Sub Regional RTEP Committee PJM West

February 21, 2020

Project Correction

AEP Transmission Zone: Baseline Project

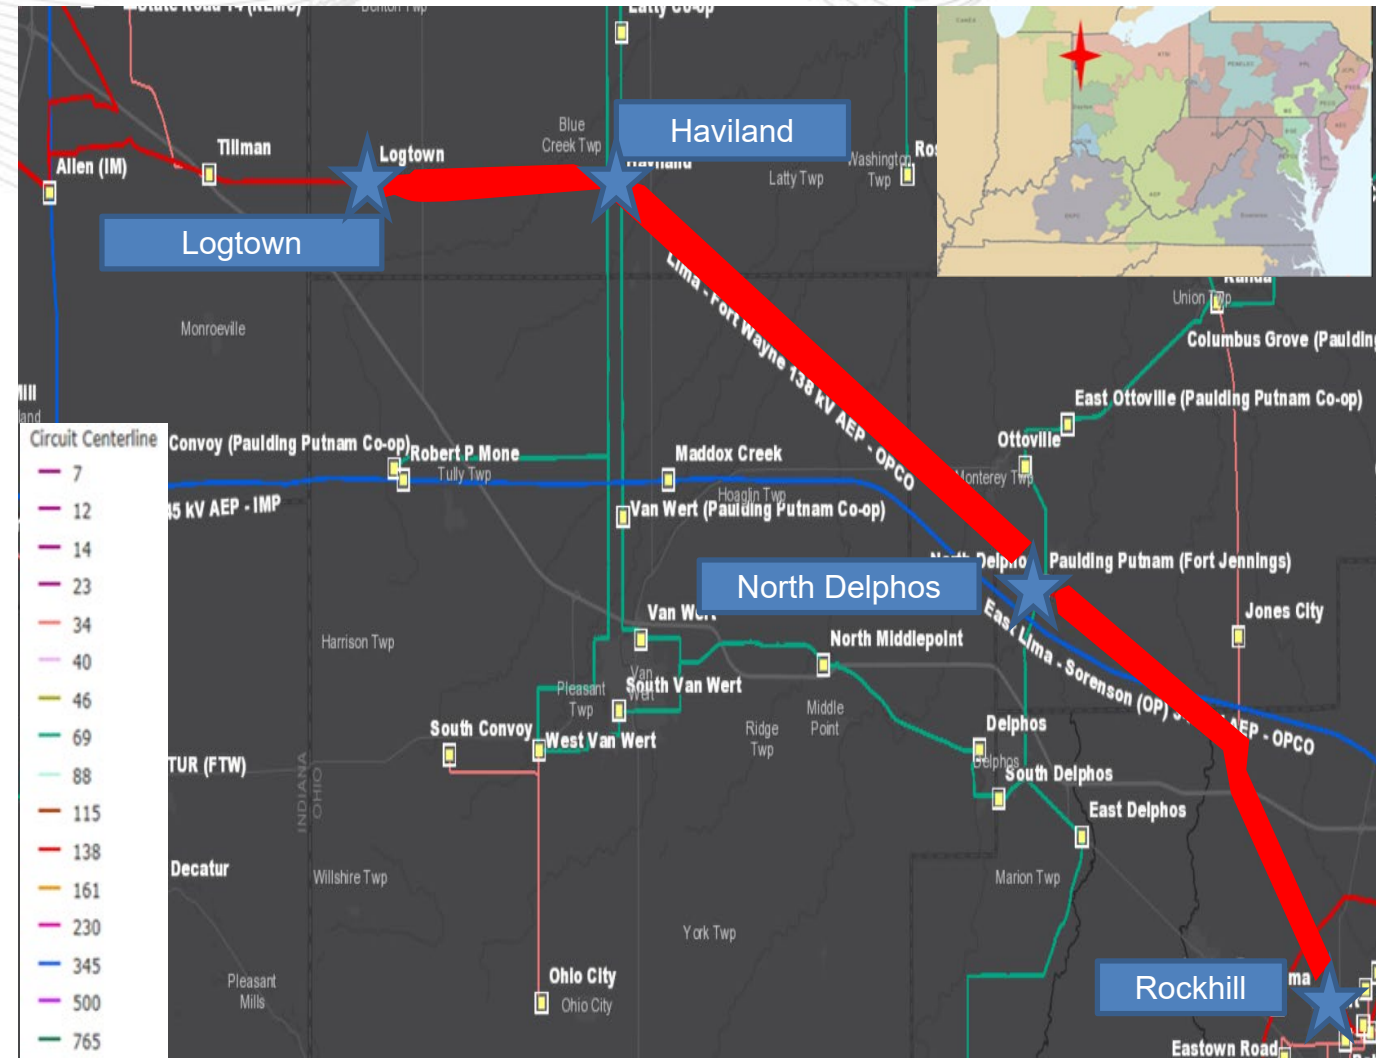
- The Logtown – North Delphos 138 kV line is overloaded for multiple contingencies in the winter case. (FG# GD-W290, GD-W291, GD-W39 and GD-W40)

- Convert S1563.2-1 into baseline (**B3036**)
- ~~S1563.2: North Delphos – Rockhill 138 kV: Rebuild 15.4 miles of double circuit 138 kV line utilizing 1033 ACSR 1033 ACSR conductor (296 MVA rating)~~
- S1563.1: Haviland – North Delphos 138kV: Rebuild 15.6 miles of double circuit 138kV line utilizing 1033 ACSR conductor (296 MVA rating)**

Estimated Project Cost : ~~\$24.5 M~~ **\$24.3M**
